# WORLD WAR II MEMORIAL: FDR D-DAY PRAYER DESIGN DEVELOPMENT

PRESENTATION TO THE NATIONAL  
CAPITAL PLANNING COMMISSION

## Letter Re: FDR Prayer Concept

CFA 21/JAN/21-1

## Revised Plan Options | Treatment of the Center

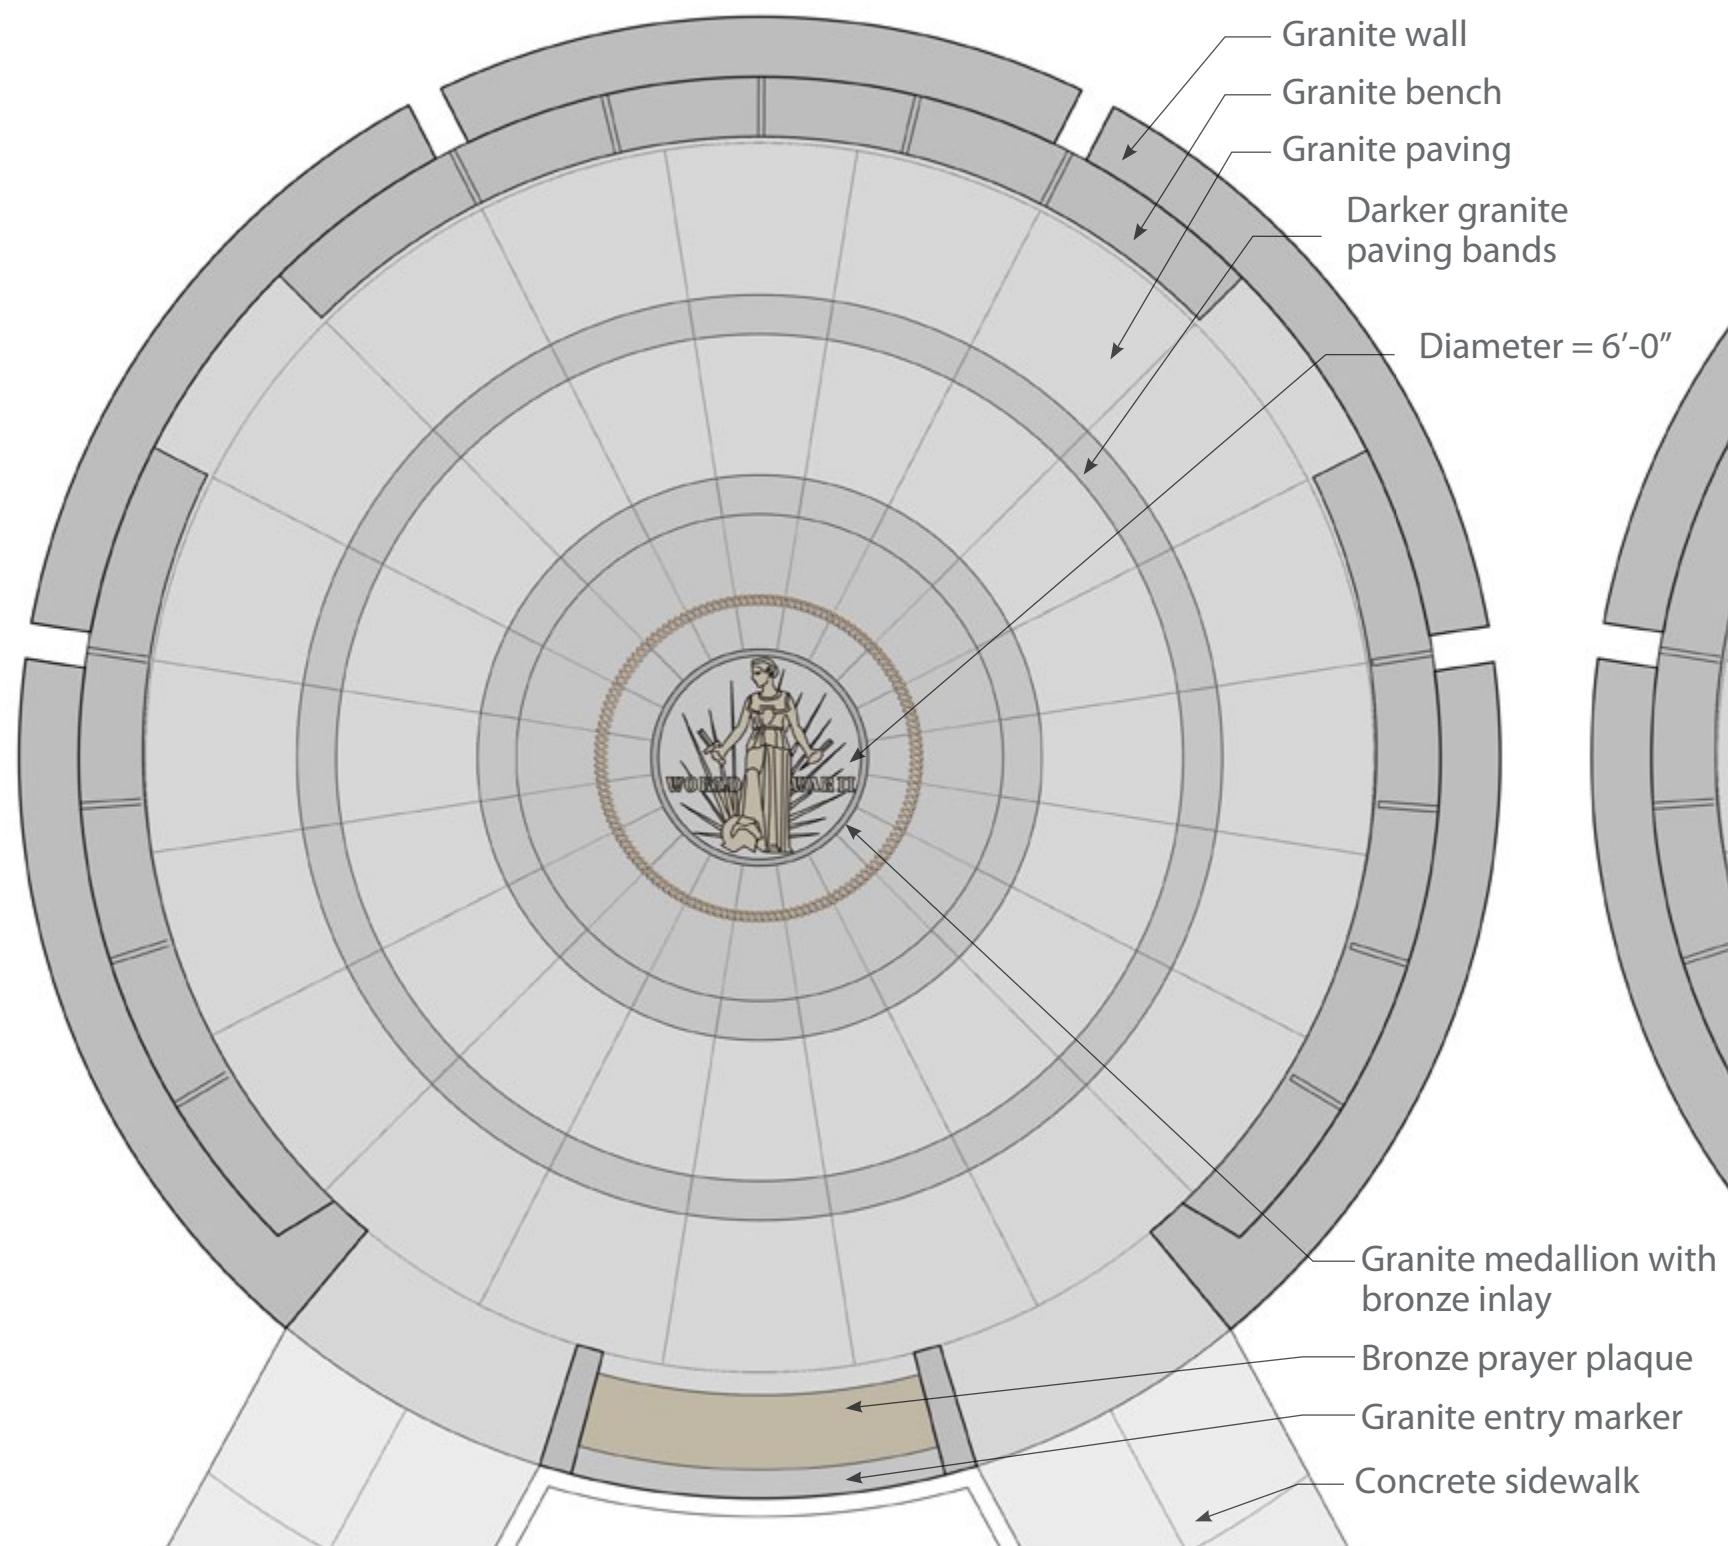
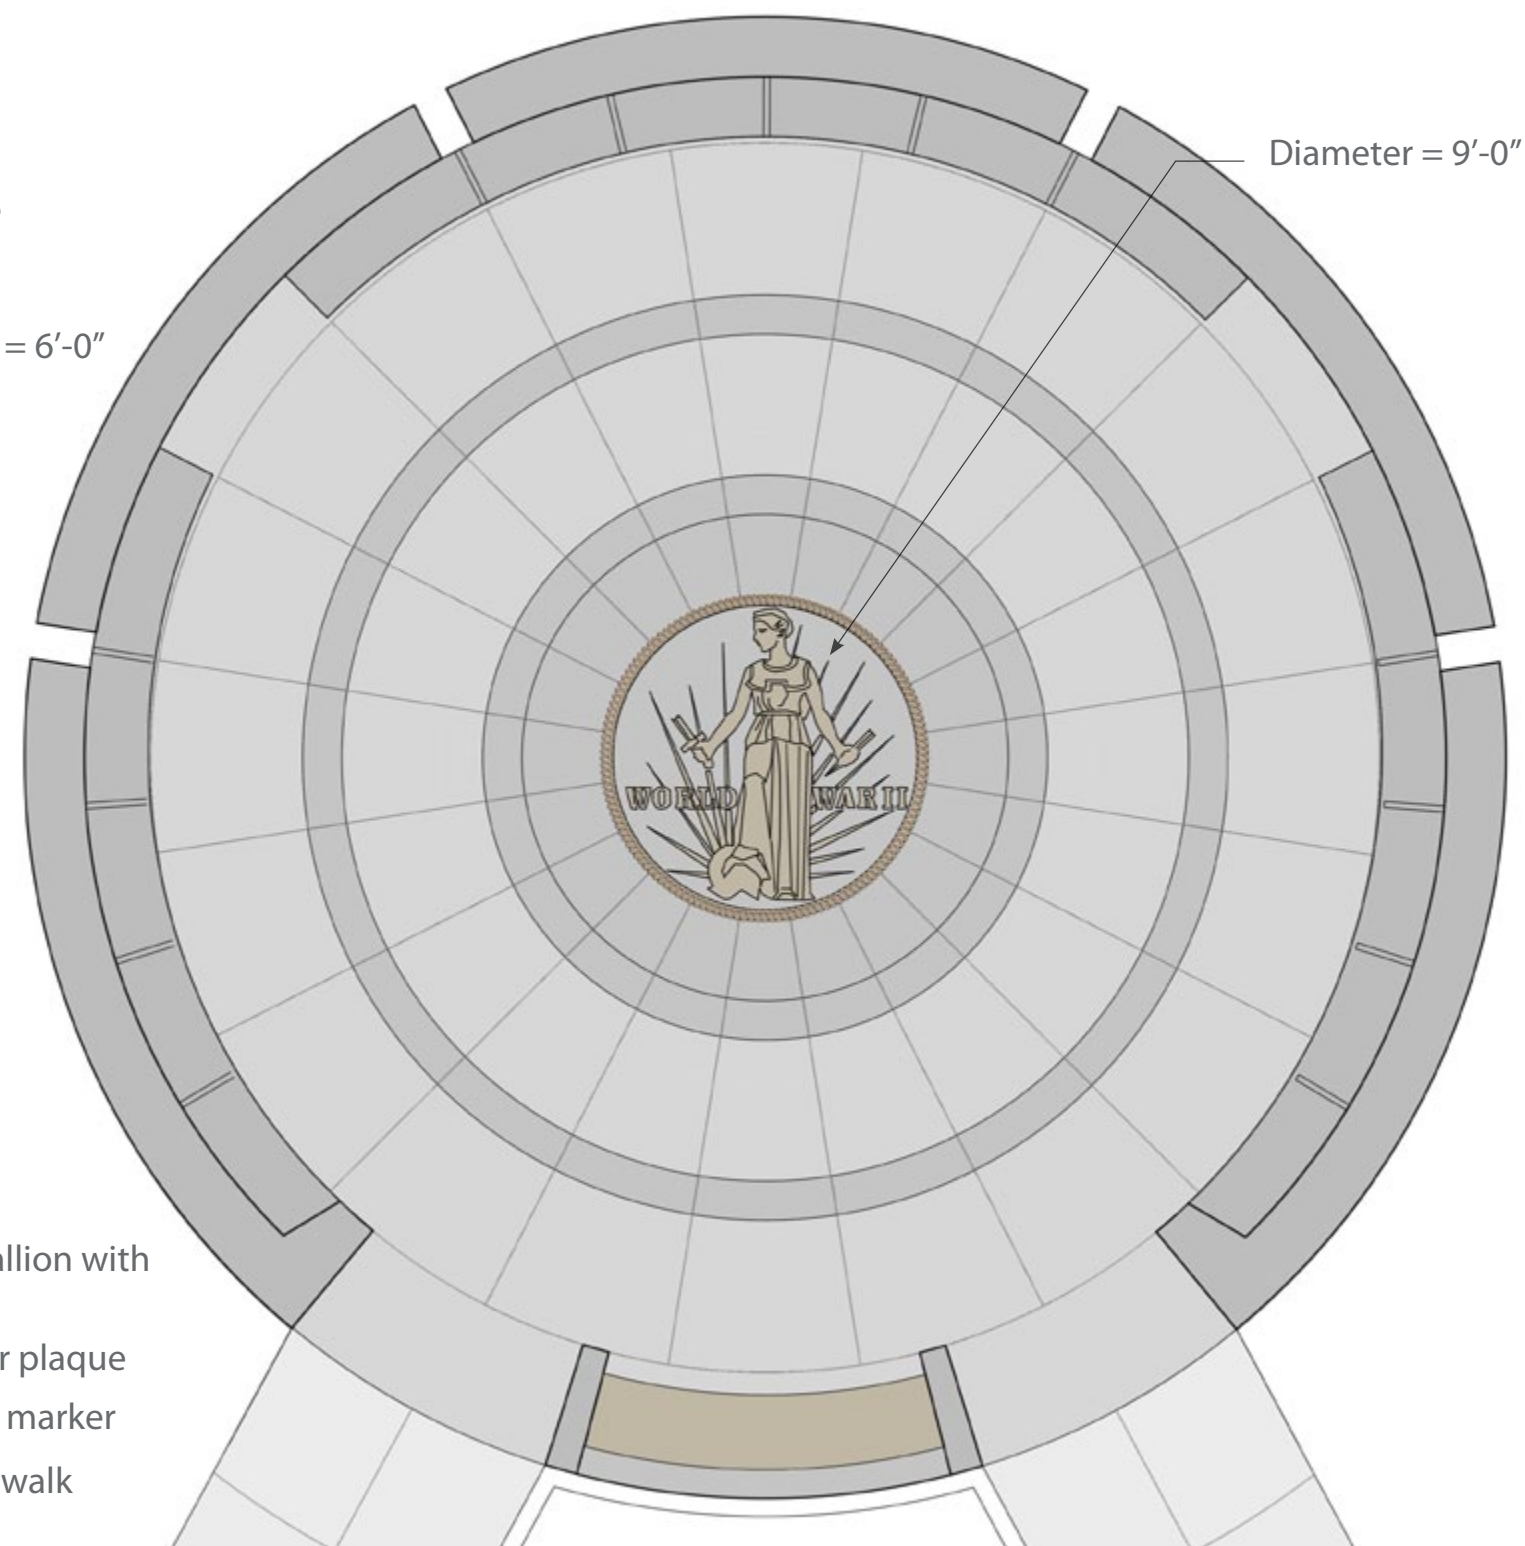
- In response to the Commission's comment regarding the Circle's 'vacant' center, a paving emblem is proposed
- WWII Atlantic and Pacific Arches provide inspiration for development of Circle's center paving design
- Bronze WWII Medal of Freedom, awarded to any veteran or civilian who performed a notable service
- Dark grey ring of 'Moss Green' granite with bronze inlay

Option 1: Granite Medal of Freedom with bronze inlay  
(matching the size of WWII medallion)

Option 2: Granite Medal of Freedom with bronze inlay  
(scaled to correspond to size of Circle and Prayer Plaque)
